Access Compliance Report

(Curb Ramps)

Intersection ID: 26283	Main Street: BEVINGTON RIDGE RD	Cross Street: BEVINGTON WOODS LN	Location: S
ADA ID: FE60A76473D2	Ramp Type: BlendTrans1	Initial Pass/Fail: Fail	Overall Compliance: No
Codes/Mitigation Info/Possible Solution		Field Measurements/Component Compliance	
Severity Score: 8.75

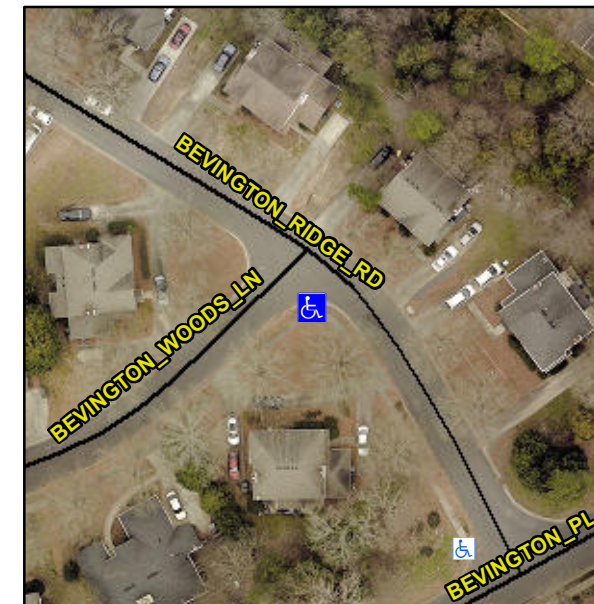
Not Found, R304.5.1

Compliance	Description	Data	Compliance	Description	Data
N/A	Ramp Length (in)	47.0	Yes	BlendTrans Slope (%)	2.6
No	Ramp Width (in)	38.0	Yes	BlendTrans XSlope (%)	0.2
N/A	Flare Type LT	N/A	N/A	Flare Type RT	N/A
N/A	Flare Slope LT (%)	N/A	N/A	Flare Slope RT (%)	N/A
N/A	Flare Traversable LT?	N/A	N/A	Flare Traversable RT?	N/A
N/A	Landing Length (in)	N/A	N/A	DWS Provided?	N/A
N/A	Landing Width (in)	N/A	N/A	DWS Contrast?	N/A
N/A	Landing Slope (%)	N/A	N/A	DWS Length (in)	N/A
N/A	Landing X Slope (%)	N/A	N/A	DWS Full Width?	N/A
N/A	Landing Curb? (Y/N)	N/A	N/A	DWS Offset (in)	N/A
N/A	Shared Landing?	N/A			
N/A	Gutter Ponding?	N/A	N/A	Gutter Slope (%)	N/A
N/A	Gutter Lip Ht (in)	N/A	N/A	Gutter X Slope (%)	N/A
N/A	Painted X Walk1?	No	N/A	Painted X Walk2?	No
	X Walk 1 Direction	To NE		X Walk 2 Direction	To NW
	X Walk 1 Width (in)	N/A		X Walk 2 Width (in)	N/A
	X Walk 1 Slope (%)	6.8		X Walk 2 Slope (%)	3.5
	X Walk 1 X Slope (%)	3.1		X Walk 2 X Slope (%)	1.5

N/A	Ramp inside XWalk1?	N/A	N/A	Ramp inside XWalk2?	N/A
	Road Slope (%)	3.7		Clear Space?	N/A
	Road X Slope (%)	3.8	N/A	Clear Space to XWalk (in)	N/A
N/A	Any Obstructions?	N/A	N/A	Storm Grate/Utility Hazard?	N/A
	Obstruction Type			Storm Grate/Utility Type	
		N/A			N/A
			Yes	Surface Condition? (G/P)	Good
			No	Curb Slope (%)	17.8

Remove & Replace Curb Ramp With Two New Directional Ramps or Equivalent.
